## **System Impact Assessment Report (Addendum)**

### **Northern Ontario Shunt Capacitors**

*CAA ID 2008-352*

**Final Report**

**Figure 2:** Revised Hanmer SC22 connection

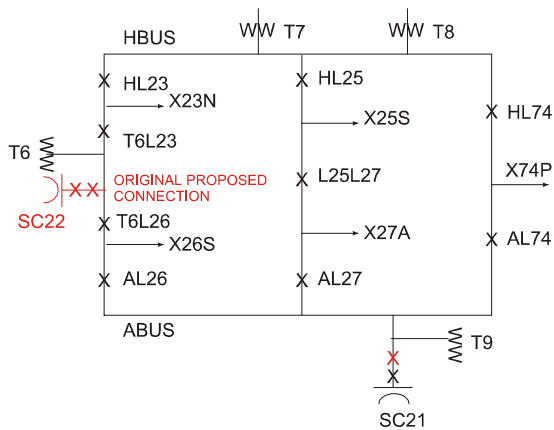
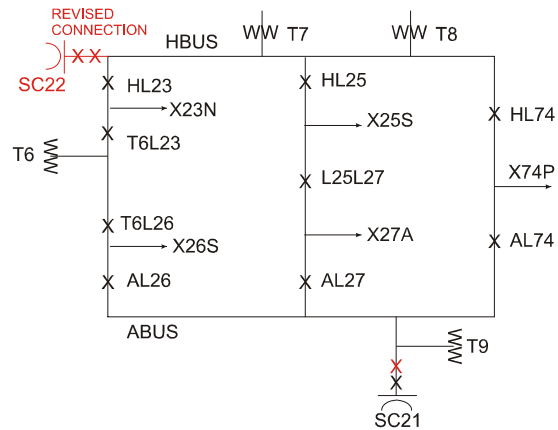
In the original assessment, Hydro One proposed to install a 149 Mvar @ 220 kV capacitor at Hanmer TS, SC22 to be connected between breaker T6L23 and T6L23 as shown in **Figure 1**. The in service of this capacitor was originally planned for December, 2010.

Due to construction limitations, Hydro One has revised its planning specifications and is proposing to install the capacitor on the H bus as shown in **Figure 2**. The in service of this capacitor has now been rescheduled for December, 2011.

The proposed modifications to the connection arrangement will not have a material adverse effect on the IESO-controlled grid.
